Agenda Item #: 1 - HOLDOVER

SUB-002586-2023

Athey Place Subdivision

ATHEY PLACE SUBDIVISION

DETAIL SITE PLAN

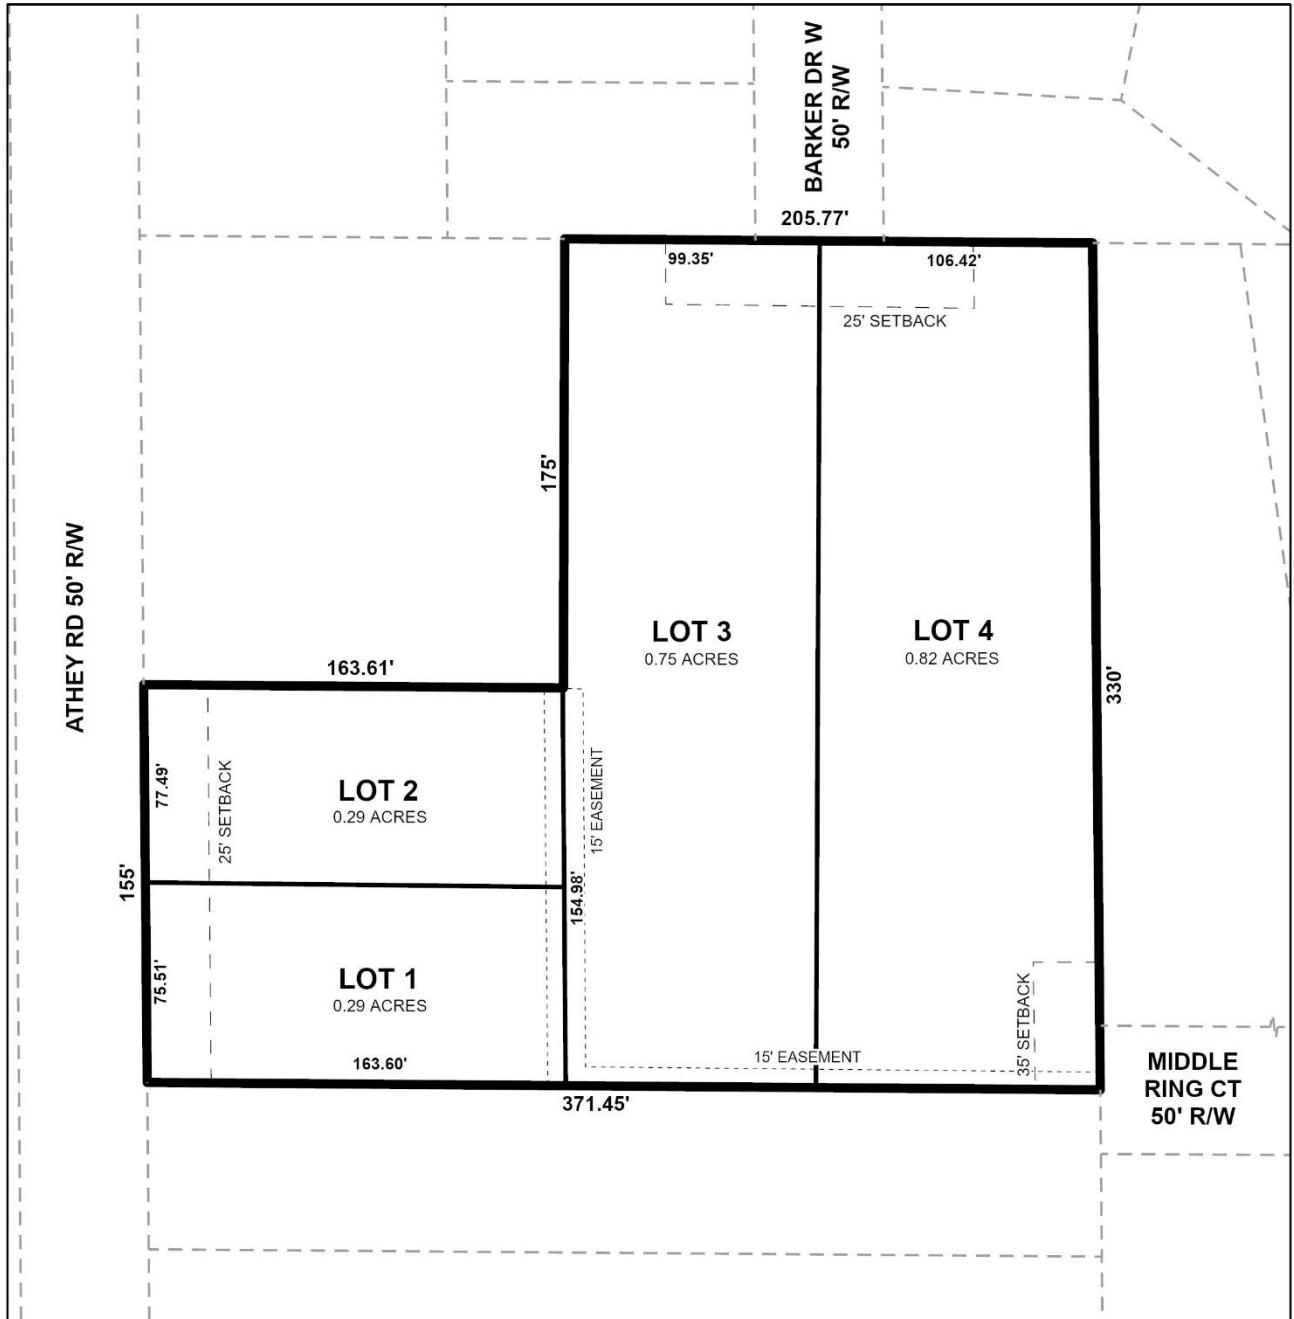
The subject site has linear frontage on Athey Road, a minor street with curb and gutter, and a compliant 50-foot right-of-way; therefore, no dedication would be required along Athey Road. The site also has closed-end frontage on Barker Drive West and Middle Ring Court. As on the preliminary plat, the street names and right-of-way widths of all abutting streets should be retained on the Final Plat.

As per Section 6.B.3 of the Subdivision Regulations, a turnaround is required for new lots at the end of a closed-end street. However, as access to Middle Ring Court is proposed to be denied, no turnaround would be required within Lot 4. No turnaround is required at the Southern terminus of Barker Drive West due to its short length.

A minimum building setback line of at least 25 feet should be retained along Athey Road for Lots 1 and 2, and from the South terminus of Barker Drive West for Lots 3 and 4 on the Final Plat. A 25-foot minimum building setback line should be retained on the Final Plat for Lot 4 as blocked-out from the West terminus of Middle Ring Court. The notes on the preliminary plat stating that "Access to Middle Ring Road is denied" should be corrected to state "Access to Middle Ring Court is denied".

The subject site is served by public water and sanitary sewer services, and the proposed lots exceed the minimum size requirements of the Subdivision Regulations. As on the preliminary plat, the lot size labels in both square feet and acres should be retained on the Final Plat, or a table should be furnished on the Final Plat providing the same information.

All proposed lots contain drainage and utility easements; therefore, the note on the preliminary plat stating that no structure may be constructed or placed within any easement without the permission of the easement holder should be retained on the Final Plat, if approved.

- 1) *Retention of the names and right-of-way widths of all abutting streets on the Final Plat;*
- 2) *Retention of at least a 25-foot minimum building setback line along Athey Road for Lots 1 and 2, and as blocked-out from the South terminus of Barker Drive West for Lots 3 and 4;*

- 3) *Retention of at least a 25-foot minimum building setback line on Lot 4 as blocked-out from the West terminus of Middle Ring Court;*
- 4) *Revision of the two (2) notes stating "Access to Middle Ring Road is denied" to state "Access to Middle Ring Court is denied";*

- 5) *Retention of the lot size labels in both square feet and acres on the Final Plat, or the furnishing of a table on the Final Plat providing the same information;*

- 6) *Retention on the Final Plat of the note stating that no structure may be constructed or placed within any easement without the permission of the easement holder;*
